SUBMISSION ON DA2020/0285

Lot 29 DP 11280 11 Bungaloe Avenue, Balgowlah Hts

Alterations and additions to dwelling house including swimming pool

Submission Date: 4 May 2020

SITE PLAN / SITE ANALYSIS
SCALE 1:100

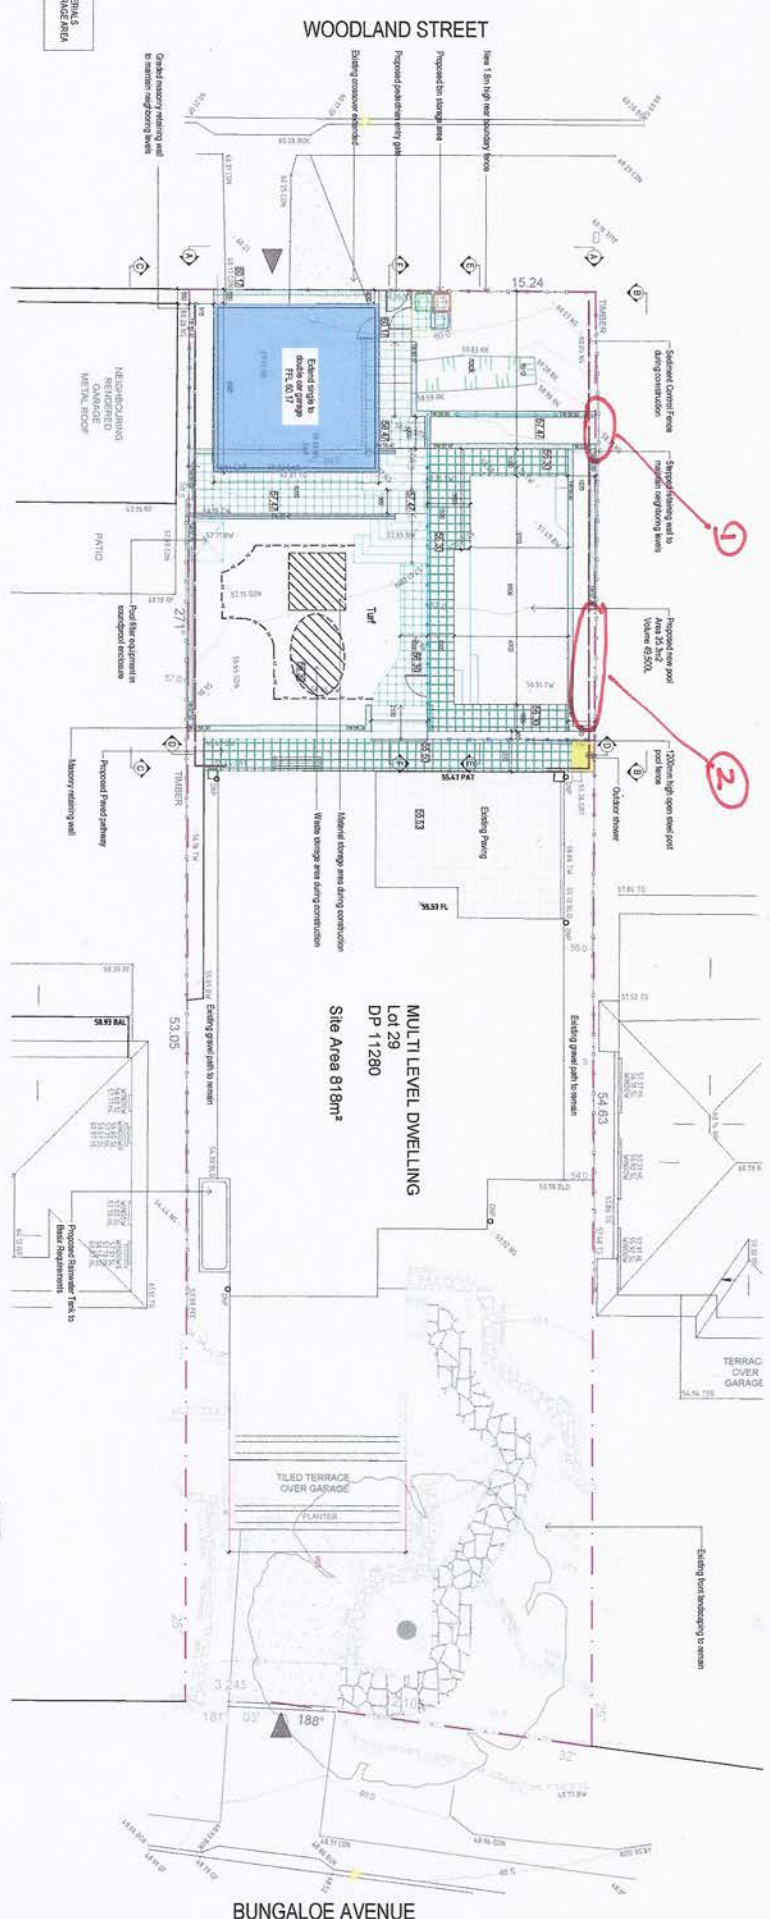
- For example, the SITE PLAN/SITE ANALYSIS , the DEMOLITION & CUT AND FILL PLAN (Top View & Northern Elevation – BB View), ELEVATION/SECTIONS (Northern Elevation -BB View) and LANDSCAPE PLAN AND SPECIFICATIONS do not show retaining walls against our property where there is a difference in land levels. We have marked these locations (1) and (2) in red on the attached plans.

- Adequate arrangements will be put in place to mitigate changes in the water flow in response to the installation of the various retaining walls, the underground pool and surrounds and increase in paved surface.
- Planter box on north side of pool needs to be constructed and drained to avoid water damage to the boundary fence and flow onto our property. The current plan does not specify a planter box side wall against our boundary ((2) on plans).
